## 1. Waterloo Metro Quarter Over Station Development – Response to Authority Comments

ptc. have been engaged by WL Developer Trust (WLD) to prepare a response to traffic related comments raised by the Authorities in relation to the proposed Waterloo Metro Quarter Over Station Development.

### 2.1 City of Sydney

Figure 1 - Access to Retail Tenancies from Northern Loading Dock

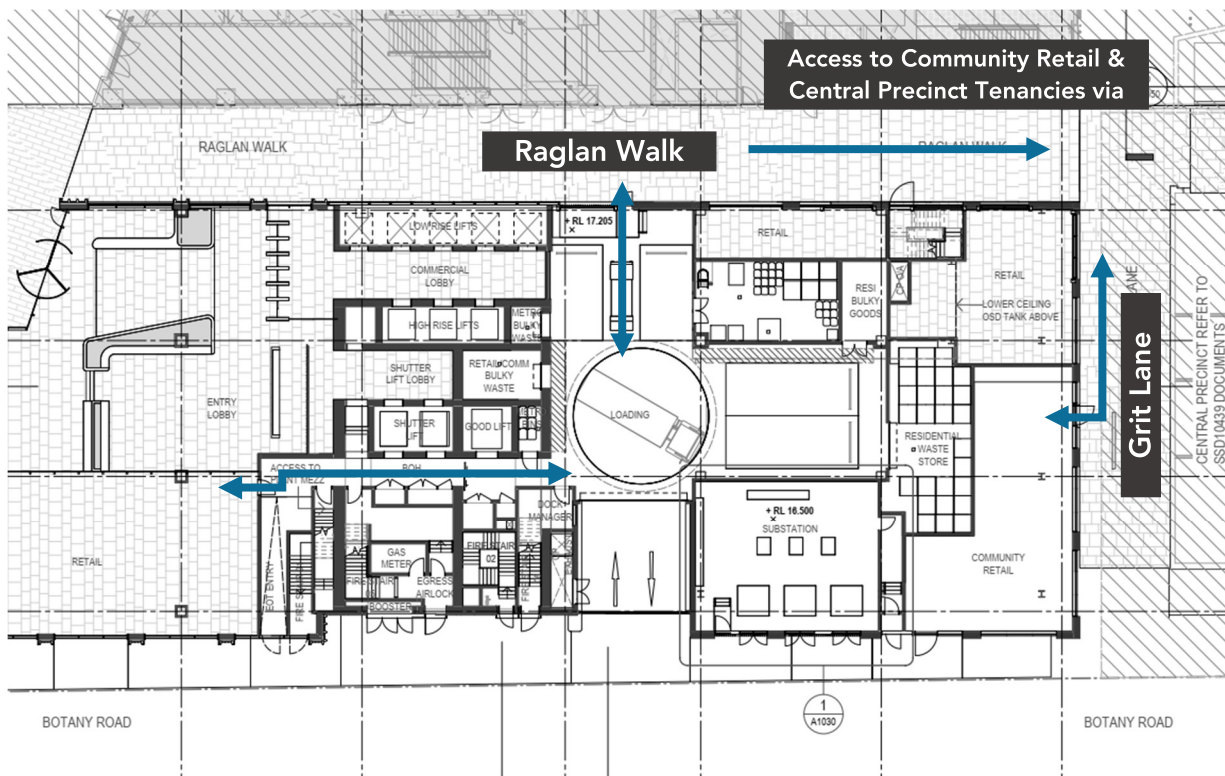
*Provide further information on how the proposed retail premises can be serviced from basement loading docks.*

### 2.3.4 ptc. Response to Item 7(e)

Access from the Central Precinct retail tenancies to the Northern loading dock is provided in the following diagrams.

Figure 1 - Cope Street and Raglan Street Intersection Upgrade

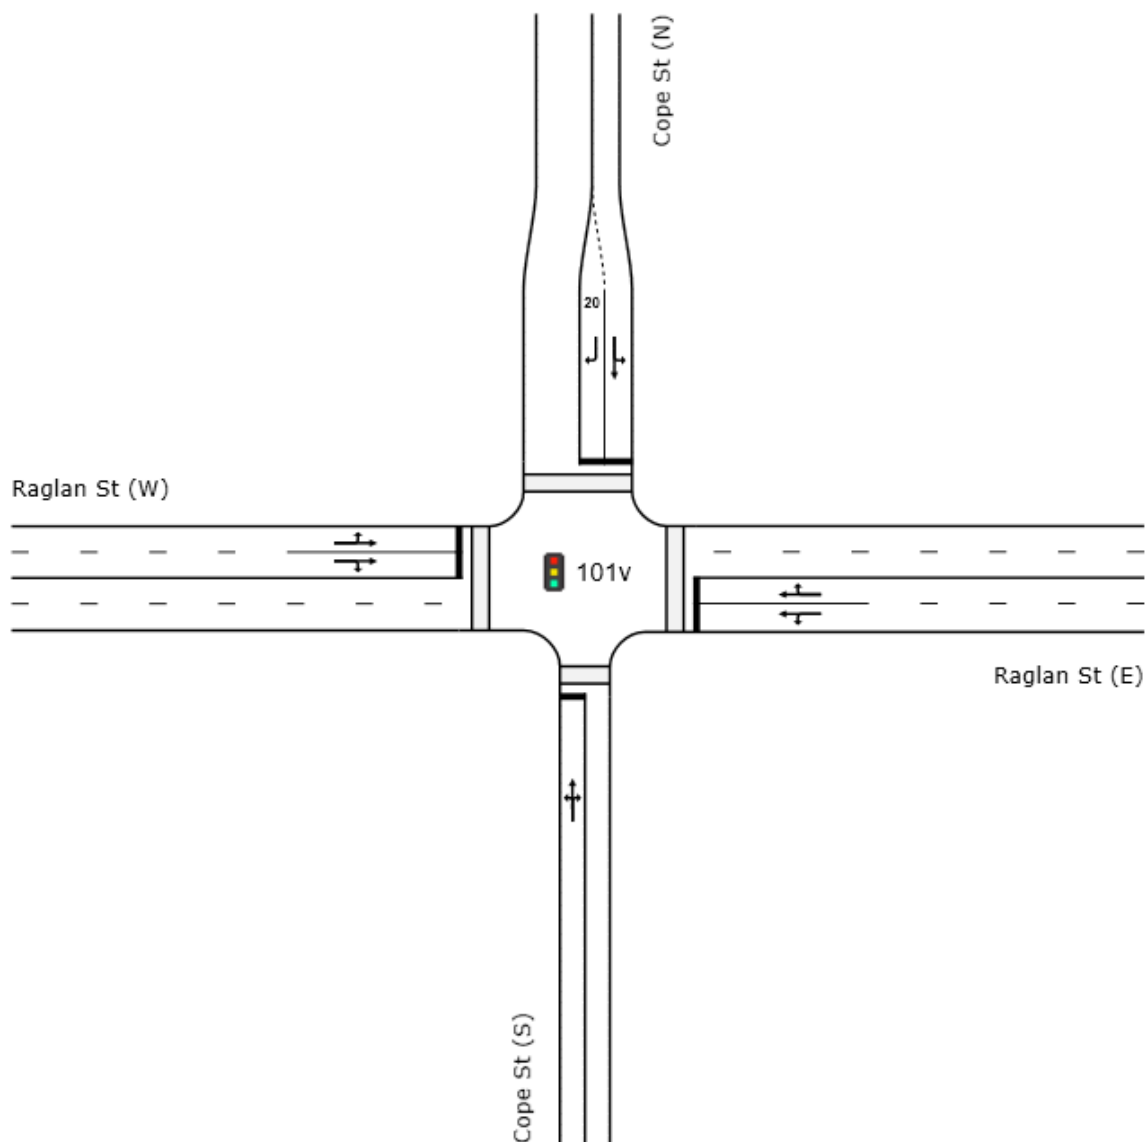
*“The traffic modelling should include changes to the street network and intersections proposed as part of the Metro development.”*

The intersection is currently configured as a roundabout. The intersection is planned to be converted to a signalised intersection. The arrangement of the intersection is illustrated in Figure 1.

drawing title  
Building 3  
Ground Floor Assessment

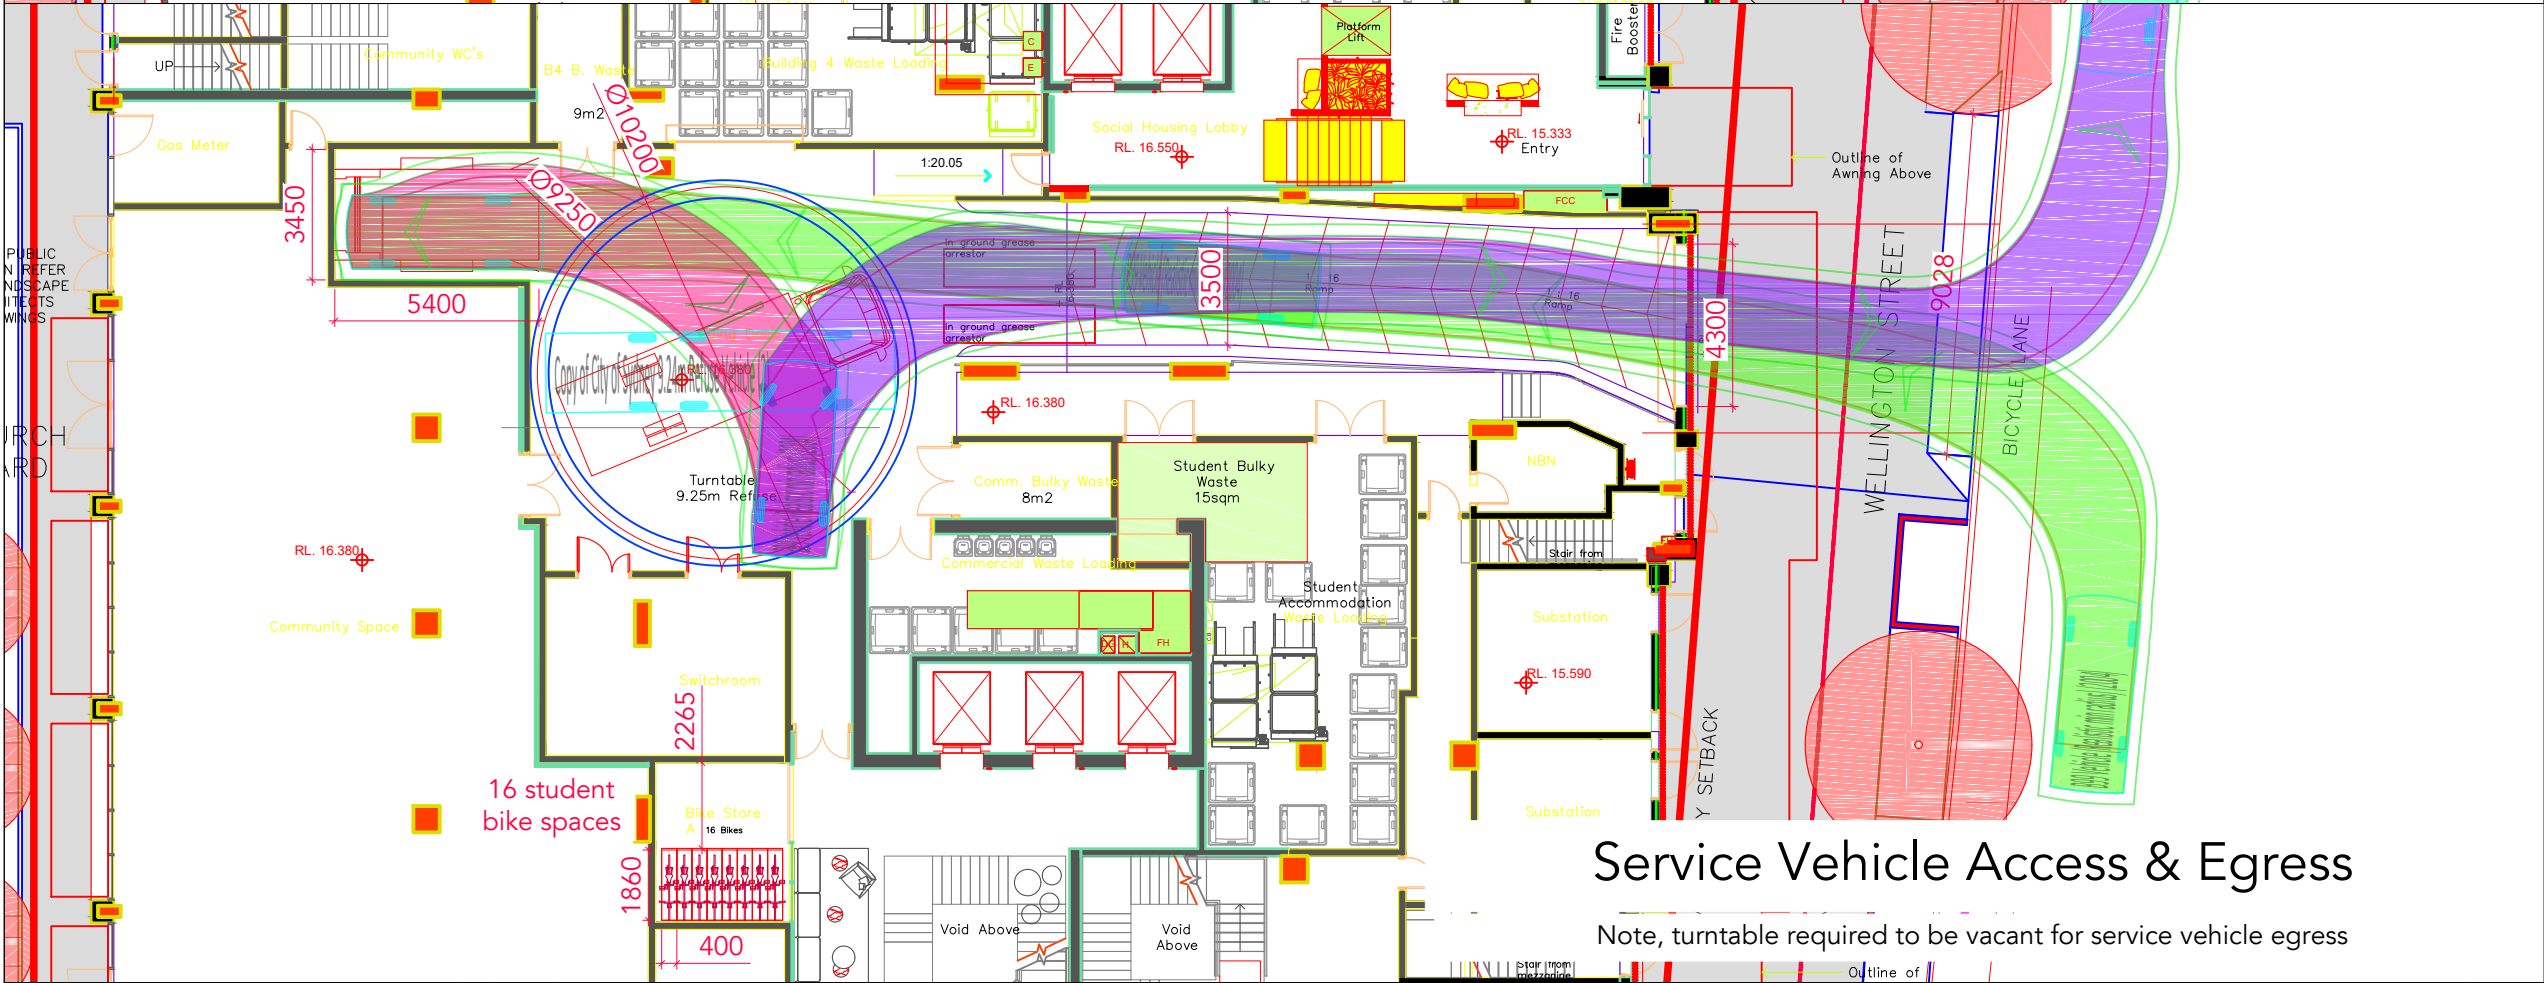
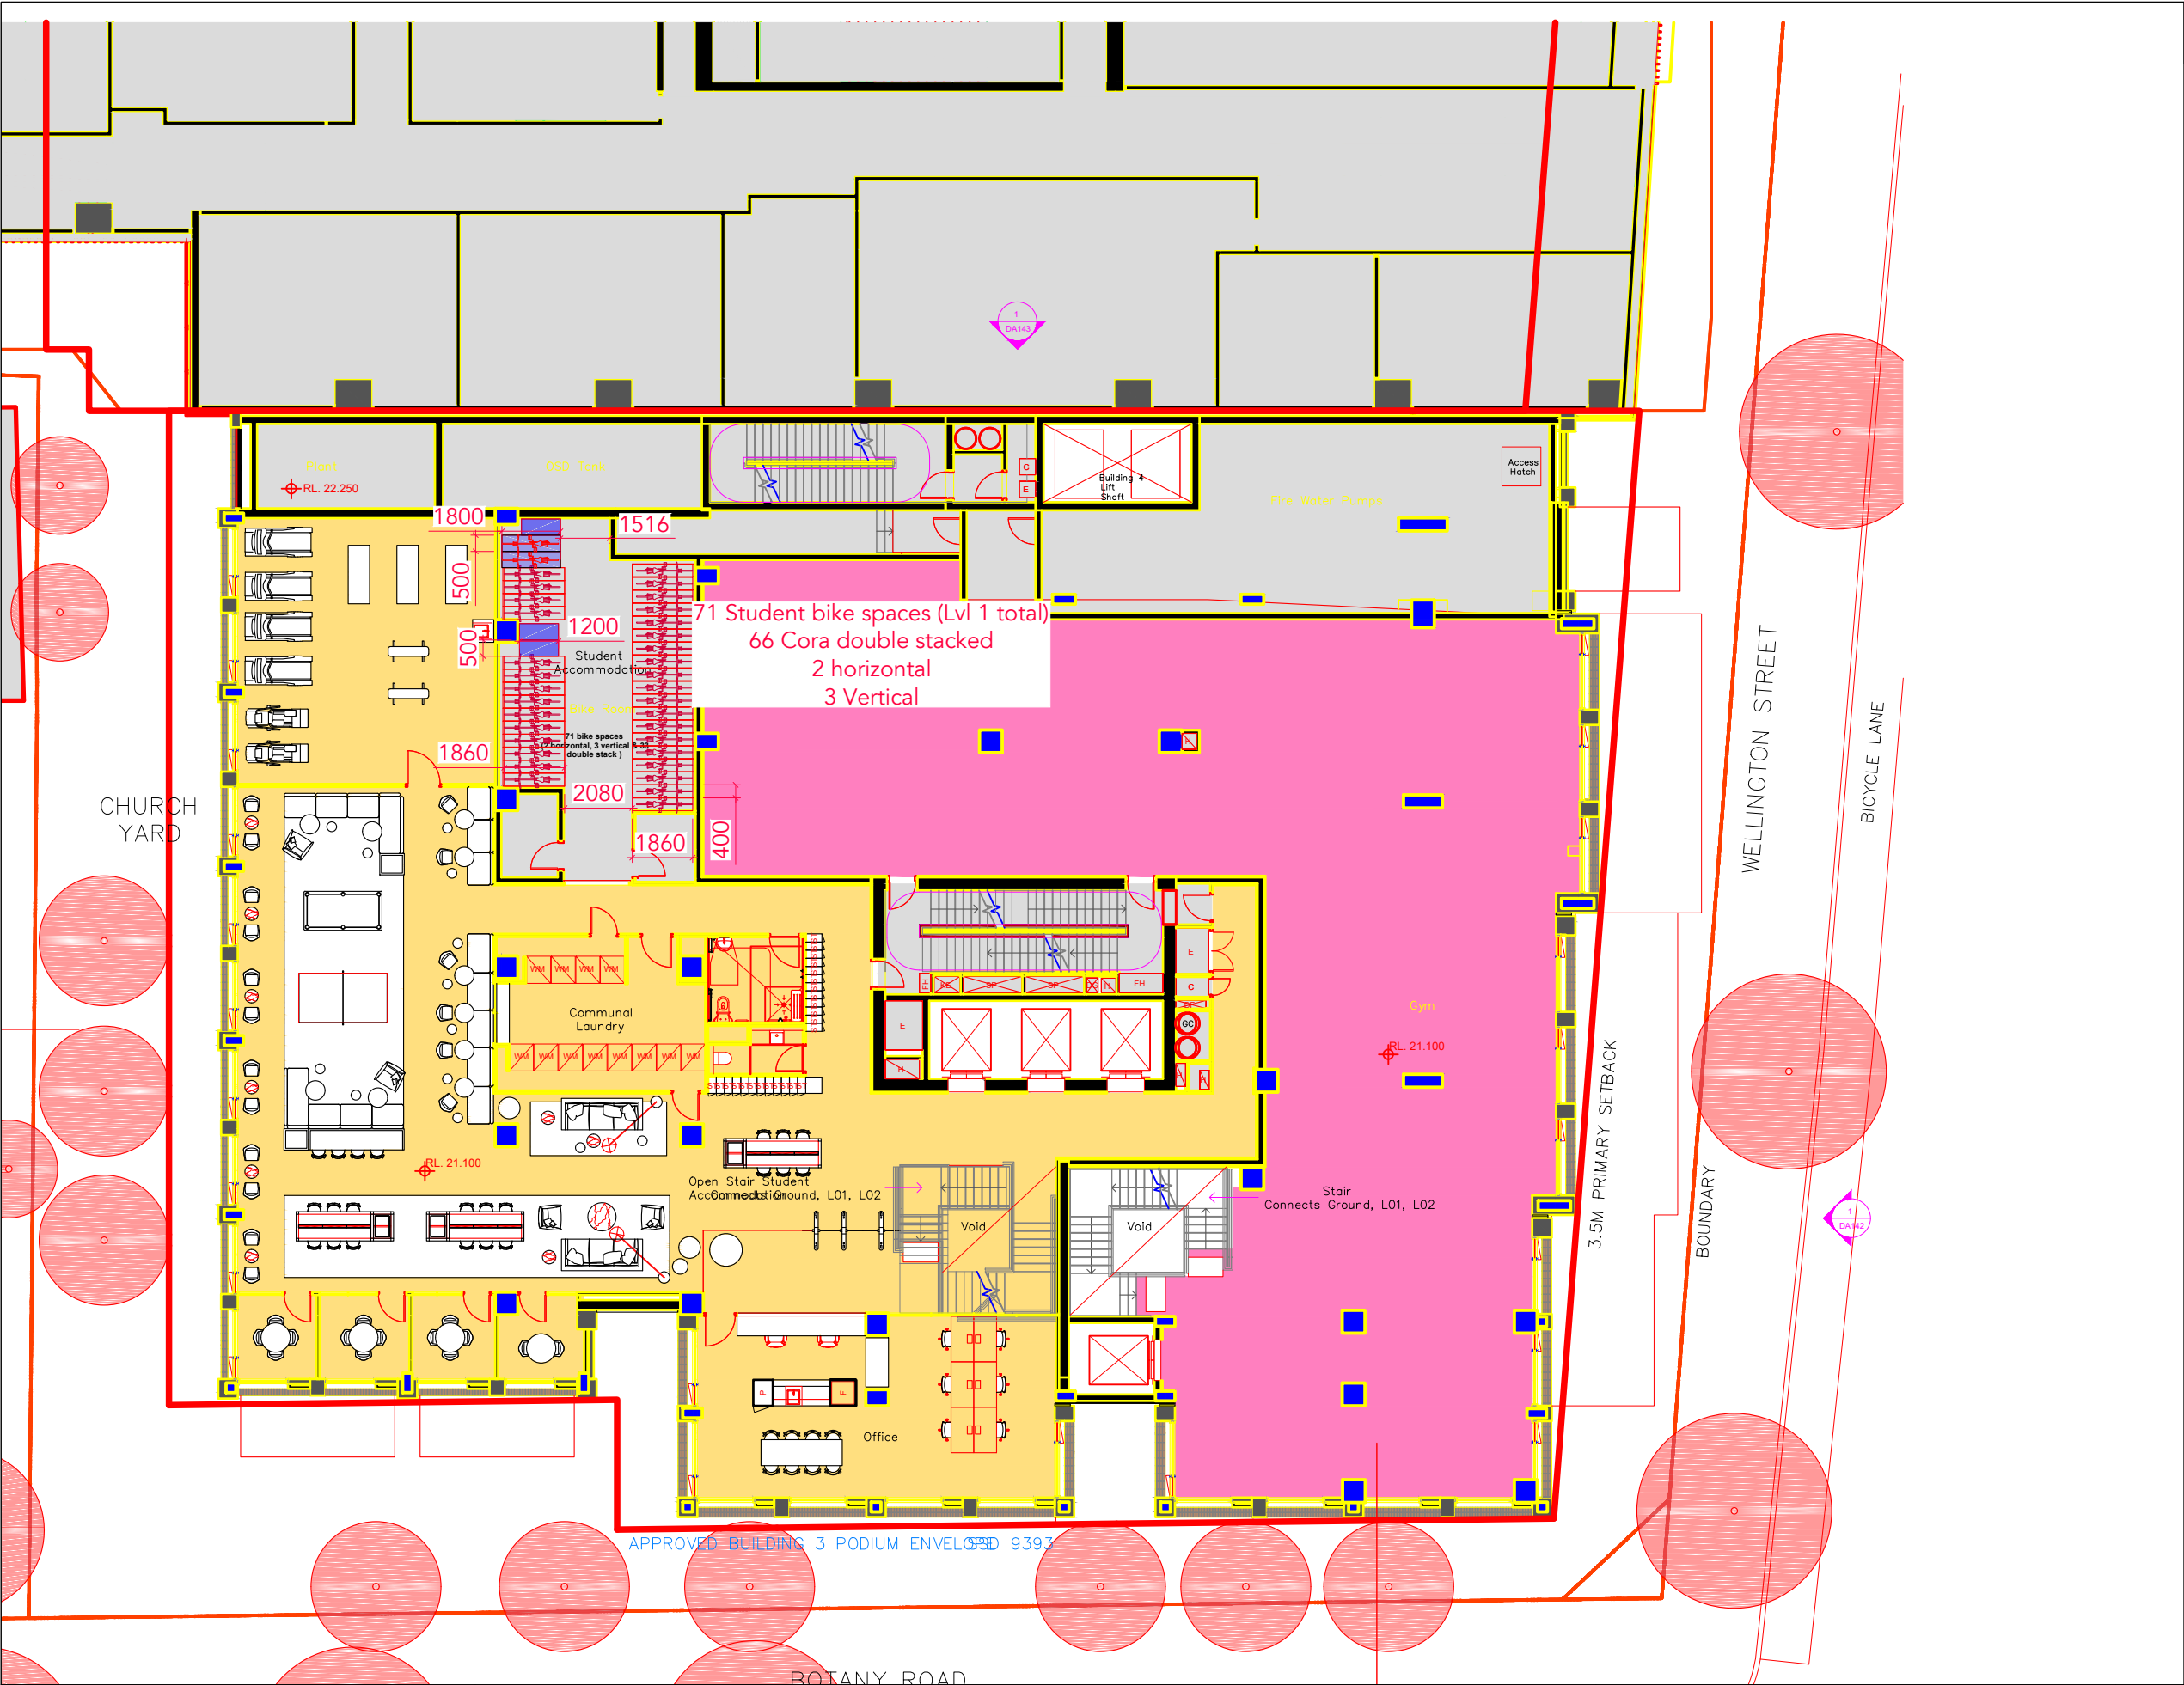
*The proposal presents a shortfall of loading and servicing and should be provided as per the SDCP 2012 rates.*

*The turntable is to be a minimum dimension of 10.5 metres in accordance with the City's Guidelines for Waste Management in New Developments and Section 3P of the Waterloo Metro Design and Amenity Guidelines.*

It should also be noted that the Southern Loading Dock has been amended to provide an additional B99 courier service vehicle bay. The revised concept loading dock layout has been reviewed and a swept path assessment has been undertaken. A B99 vehicle is able to enter the site in a forward direction upon entry and egress from the loading dock in a forward direction is also achieved. It is noted that the egress of the B99 courier/service vehicle will require the turntable to be vacant. This can be readily managed as deliveries and maintenance vehicles are managed through the site-wide online booking system.

Overall, ptc.'s review finds that the concept design for the Southern Loading Dock generally meets or is capable of complying with AS2890.1:2004 and AS2890.2:2018. Details of the swept path assessment is provided in Attachment 2.

The Northern and Southern Loading Docks have been designed to include a 9.25m diameter turntable based on a swept path assessment for the 9.25m Council refuse vehicle. The swept paths demonstrate that there is a minimum of 300mm clearance around the body of the vehicle to any walls or vertical obstructions when the turntable is in operation. The provided turntable clearance satisfies the requirements of AS2890.2.

Note, turntable required to be vacant for service vehicle egress
